UNITED STATES OF AMERICA
NUCLEAR REGULATORY COMMISSION

TEXAS UTILITIES ELECTRIC
COMPANY, et al.

(Comanche Peak Steam Electric
Station, Units 1 and 2)

AFFIDAVIT OF CASE WITNESS
JACK DOYLE

Figure 1 - Plan Detail of Steam Generator Cavities With Supports.

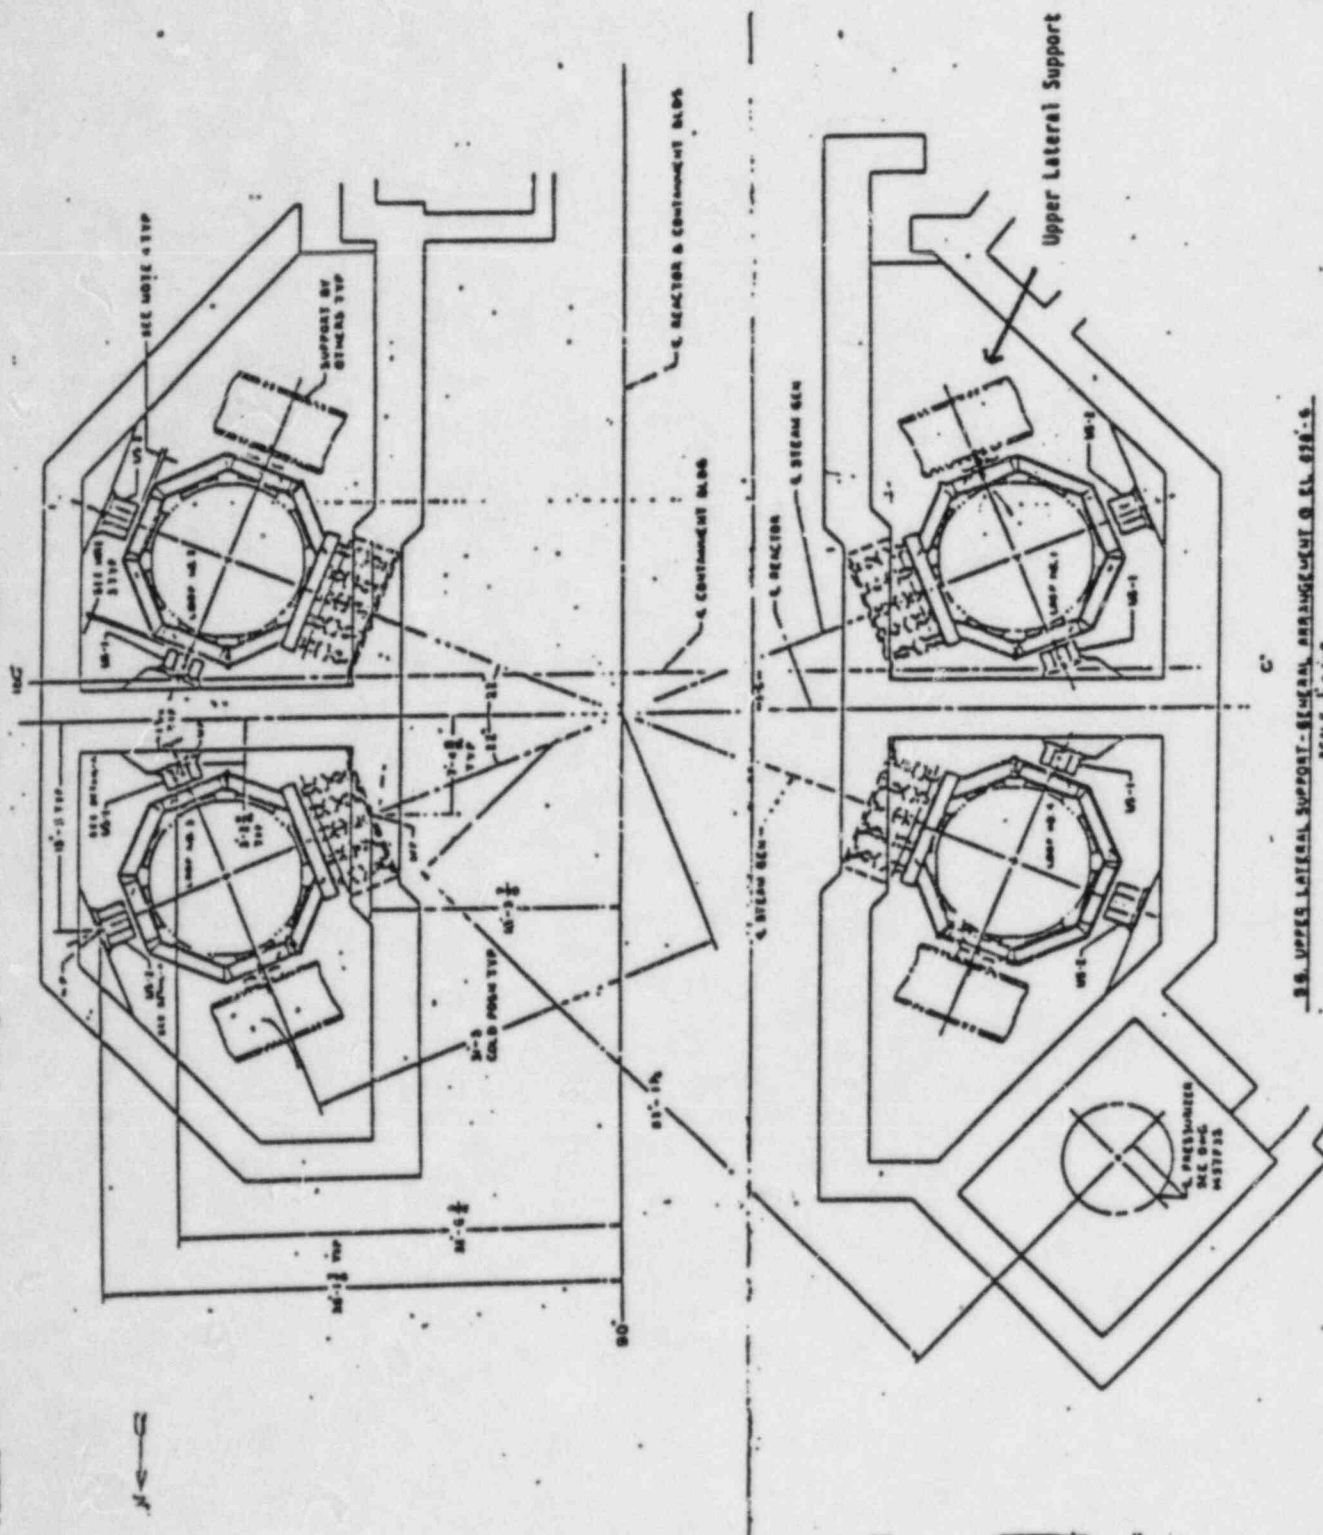
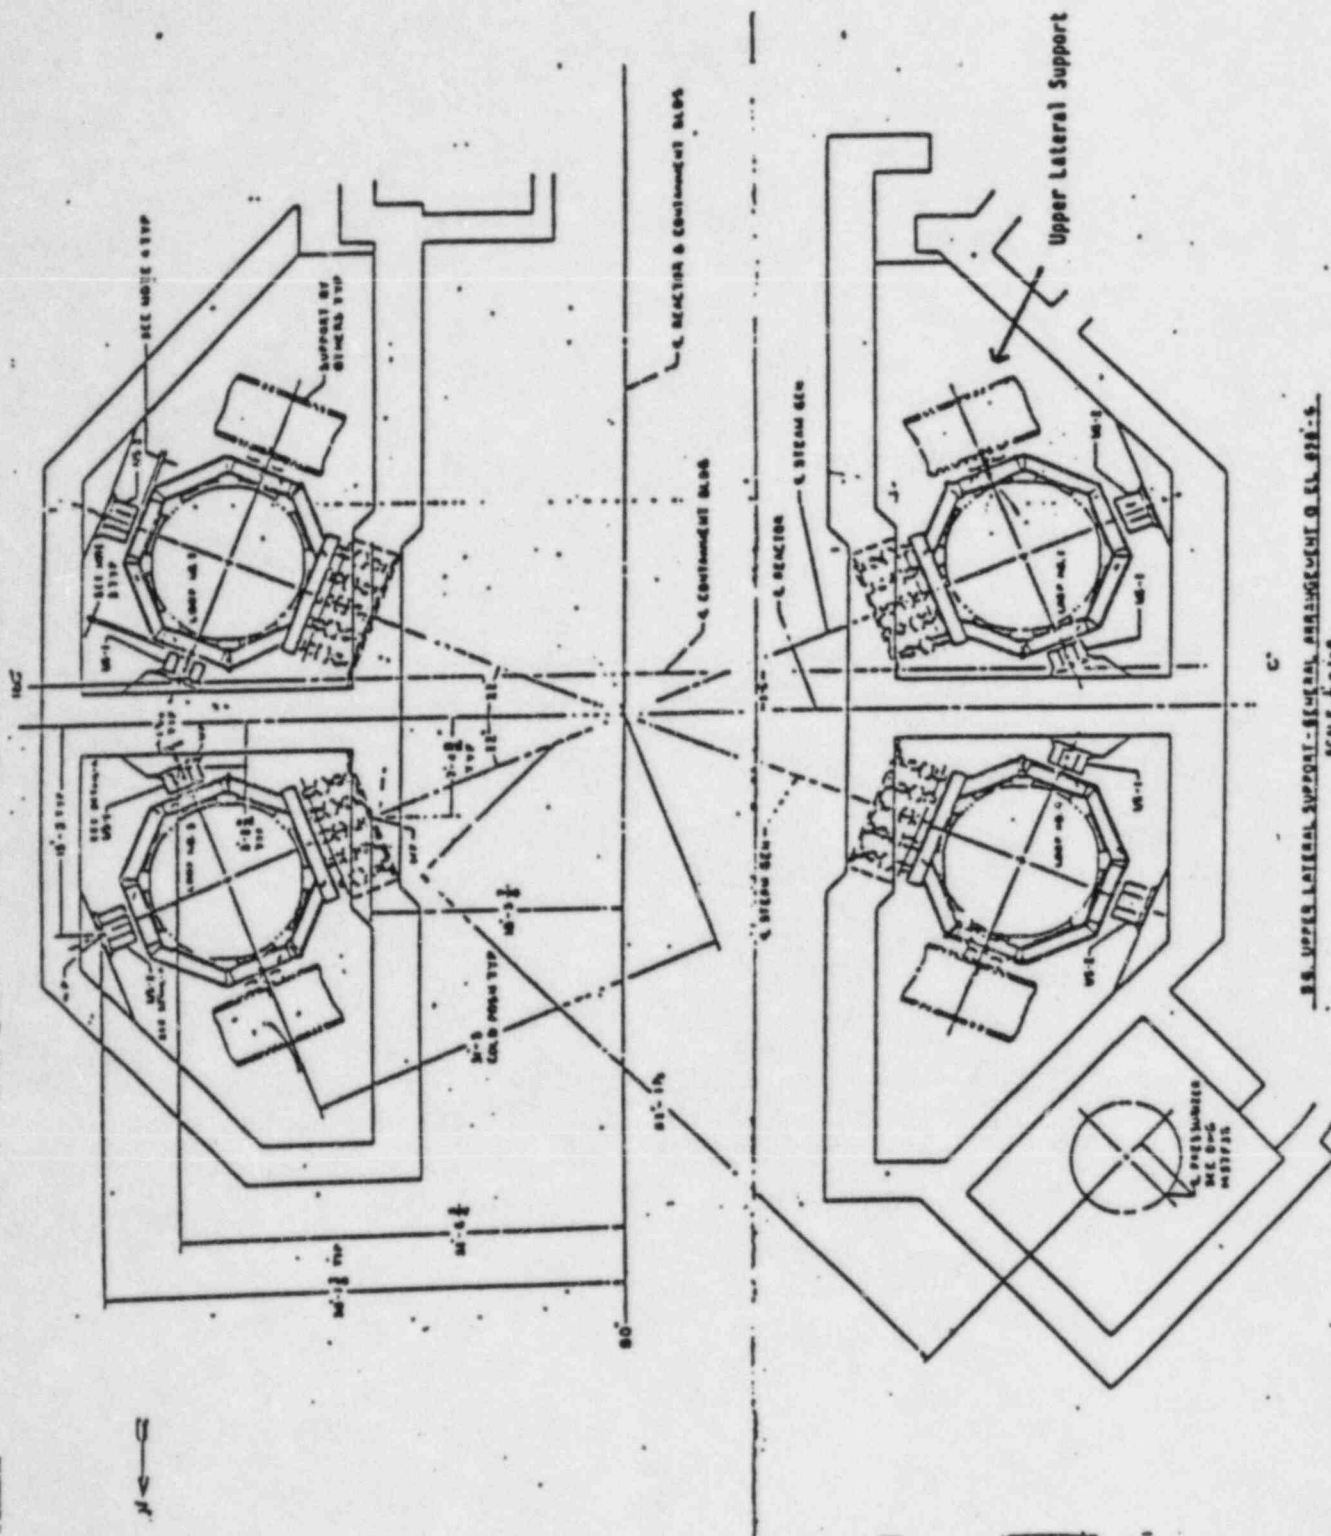
On August 14 and 15, 1984, an audit was conducted by NRC and BNL at the offices of Gibbs and Hill, Inc. (G & H), New York, on the subject of the upper lateral support beams (see Figures 1 and 2) for the steam generator compartment. At this meeting, various aspects of the structural analysis and design of the steel beam and concrete compartment were investigated. At the conclusion of the meeting, G & H was asked to provide additional information which was needed to complete the review. This material was received during the final week of August. Additional material and clarifications were required during the review process. These were obtained via telephone conversations and meetings held at BNL in Upton, NY, at NRC in Bethesda, MD and Gibbs and Hill in New York City. Specific dates for these meetings are November 5, 1984, November 13, 1984 and December 5, 1984. The BNL evaluations have now been completed and the specific findings are summarized below.

The four upper lateral restraint beams in the steam generator compartments are subjected to high thermal loads especially for the Main Steam Line Break (MSLB) case. G & H was requested to provide calculations showing that an upper bound estimate of the axial and bending stresses in the ULRB would still comply with AISC-1.6-1a requirements. These computations were included in the G & H Letter Report GTN-69363 mentioned previously. A review of the data, however, shows that the stresses were calculated for a peak temperature of 282°F which corresponds to a LOCA temperature loading. For the MSLB, the peak temperature reaches a value of 355°F according to G & H and EBASCO. For this latter case BNL carried out computations assuming rigid walls and found that the upper bound estimate (for the case when the beam is assumed fixed at both ends) of stresses would not be in compliance with AISC-1.6-1a. It should however be noted, that this assumption is unrealistically conservative and if reasonable if conservative assumptions are made concerning the concrete wall flexibility, the stresses in the beam will be reduced significantly and they then satisfy AISC-1.6-1a. A sample calculation is provided in Appendix 2. These calculations show, that even if only through thickness compressive flexibility of the wall is considered, the beam stresses would reduce to allowable levels. In reality the walls are even more flexible because of bending and shear deformations, and thus, the beam stresses will be substantially lower.

In all of the discussed calculations above, the assumptions were that the beam is rigidly held by the concrete walls, i.e., no end rotations are possible. This condition would change if the walls crack around the beam end supports. The beams could then be considered as simply supported instead of fixed. The net effect of this condition would be a further reduction in the thermal stresses. However, for the case of seismic loads this change of end fixity would increase the bending stresses by approximately a factor of two. This is due to the fact that the maximum bending moment in a centrally loaded beam with simply-supported ends is twice that of a beam with fixed ends. BNL, therefore, evaluated the adequacy of the ULRB under seismic loads assuming simply supported conditions. Both, the deflections as well as the stresses in the beam were found to be much below the allowable limits. It

1. The ULRB can satisfactorily support the high thermal loads developed the LOCA and MSLB. Since the other load components are small, the ULRB is considered satisfactory.
2. The calculations presented for the nonlinear concrete cracking of the Steam Generator Compartment are considered unverified, due to questions arising from the sample problem CA29 output from the modified EBASCO/NASTRAN Code.
3. BNL has investigated the effects of the ULRB axial loads developed during MSLB and it was found that significant shear and moment cracking will develop in the concrete compartment walls. It is reasonable to expect that significant cracking will occur both to the internal (i.e., reactor cavity walls as well as at the outer wall of the 4th compartment. Some cracking is also expected on the outside compartment walls of the other three compartments.

4. It is our engineering judgement that cracking will be localized around the beam supports and should not significantly impair the structural performance of the walls and of the ULRB.
5. The effects of the wall cracks will be to change the end fixity of of the ULRB to that of simply supported. Based on seismic loads provided by the applicant, the modification in end conditions will have little impact on the seismic response.
6. No assessment was made with respect to the effect of the cracks on radiological shielding.

Fig. 1 CA29 - Finite Element Exam. Model

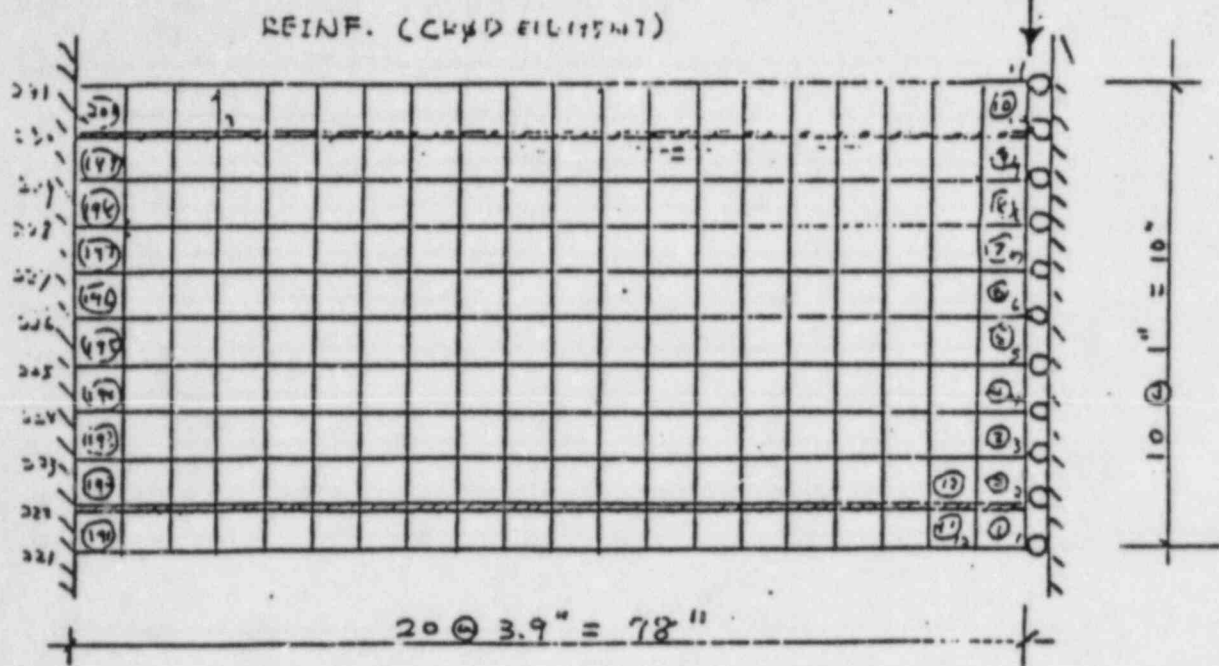
1. EBASCO was able to show a failure load of 24 kips (comparable to test data) only by assuming a tensile strength of 120 psi, which is four times lower than the strength that would be normally assumed for the concrete. (It should be noted that in the September run, the concrete tensile strength used in NASTRAN was 546 psi.)

2. The EBASCO results show that failure is associated with shear failure accompanied by very large displacements. This is contrary to the results of other studies, including the BNL/NFAP results, as well as experiments. Diagonal tension failure in concrete is typically a brittle failure at normal displacements.

On the basis of these results, BNL concludes that the EBASCO formulation of the concrete cracking model as implemented in their NASTRAN version leads to incorrect results for this verification problem. Therefore, the adequacy of the results from the code for the steam generator compartment cracking prediction are considered questionable.

Fig. 2 Concrete cracking pattern

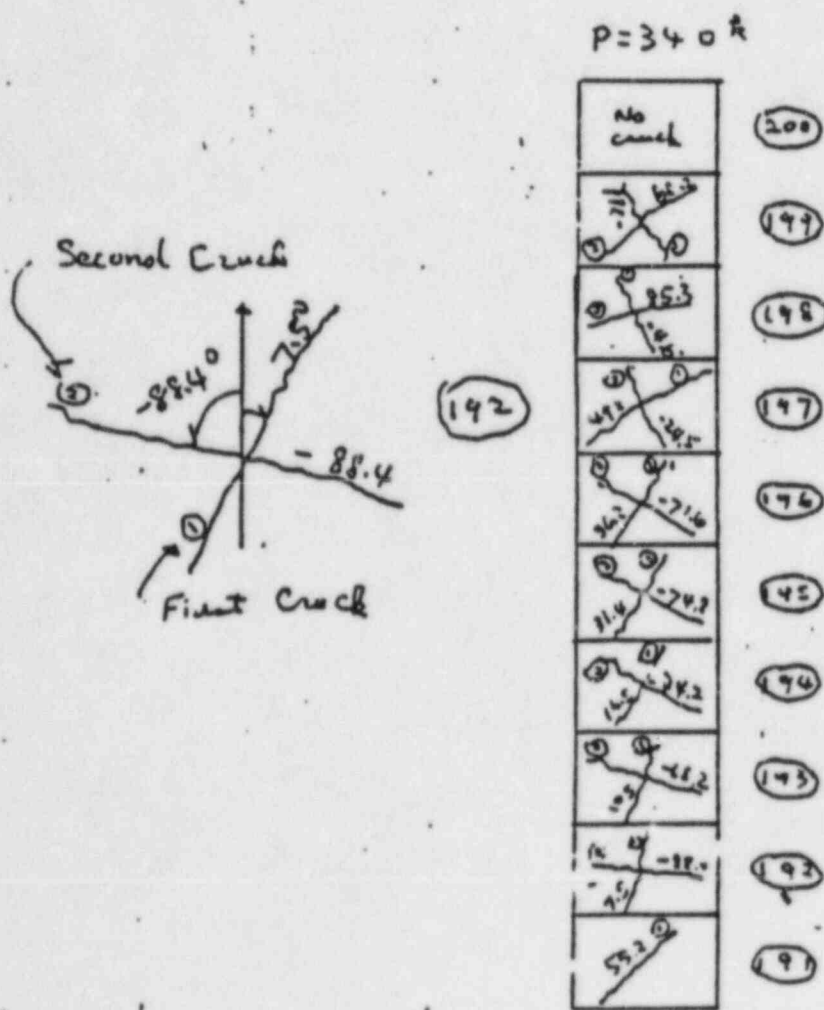
4. The multiple crack pattern shown by EBASCO for this new run indicates cracks orthogonal to each other. This result would not normally be expected and needs further explanation.

As an example, the crack angles of the ten concrete elements near the fixed end are shown in figure 2. Please note that these crack angles occur with very large displacements. Thus the example serves only as an indication of how many cracks in the element and their approximate orientation.
